Brislington Meadows, Bristol

Road Gradient Assessment Note

Prepared by: Digital analysis of planning documents on behalf of the Save Brislington Meadows Group.

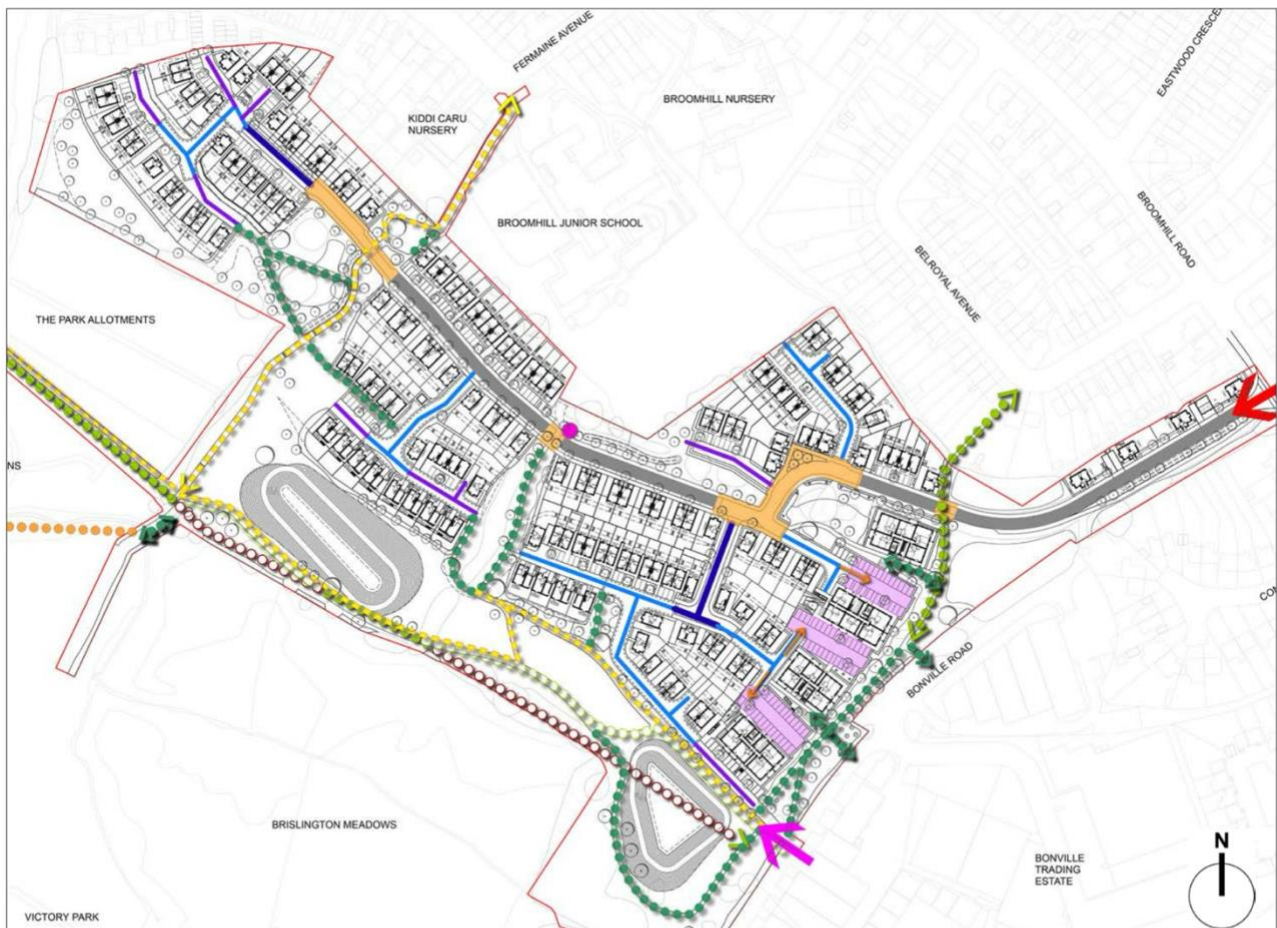
North-south roads must negotiate the slope between the Broomhill Road access point and the lower terraces – an implied level change of approximately 9m. Applied over the horizontal distances available, this produces gradients of 4.9-5.0% on the north-south link roads (Roads 4, 8

and 10).

The engineering sections note retaining walls in Sections A-A, B-B and C-C, managing level differences between terraces. Retaining walls, however, manage lateral level changes within plots; they do not reduce the longitudinal gradient of the connecting roads.

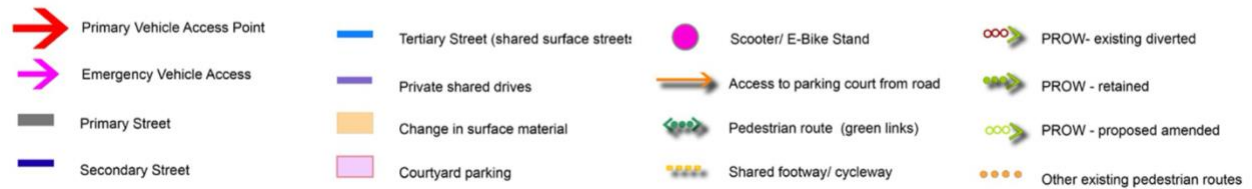
Locating the roads. No plan submitted with the application labels the road numbers used on the longitudinal sections: the Section Lines Plan at Figure 1 shows only section lines A-H, and neither the Engineering Appraisal Layouts (3066-RAP-CE-DR-C-3010/3011) nor the Site Plan nor the Illustrative Landscape Masterplan carries road numbering. The roads can, however, be located from the junction markers annotated on the profiles. Road 1 runs from the Broomhill Road site access, with junctions to Roads 2 and 3. Road 3 is the primary spine, descending from the upper part of the site with junctions to Roads 3TH, 1, 4, 8 and 10. Road 4 connects Road 3 to Road 5; Road 8 connects Road 3 to Road 9; and Road 10 runs from Road 3 to its turning head (Road 10TH). The three most severely non-compliant roads (4, 8 and 10) are thus the transverse links descending from the spine, consistent with the analysis in Section 3.4. The Section 38 adoption plans (3066-RAP-CE-DR-C-5010 and 5011) should be consulted for definitive road locations. The Street Hierarchy Plan from the Design and Access Statement is reproduced at Figure 2 for orientation; the primary street (grey) corresponds to Roads 1 and 3, and the junction relationships described above can be traced on it.
